SB, 346XP, 351, Crankcase, 2001-03

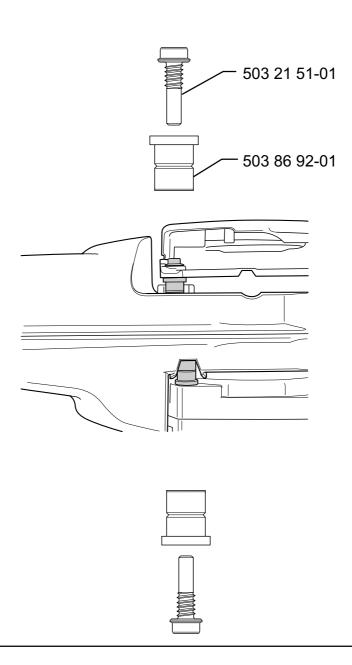
Bigger screws have been introduced for the movement limiters to achieve a more effective installation of them. The holes in the crankcase are also bigger. The new screws do not fit in older crankcases, and vice versa.

New ref. no. 503 21 51-01 503 85 69-75 **Description** Screw Crankcase **Excl. ref. no.** 503 21 88-20 503 85 69-73
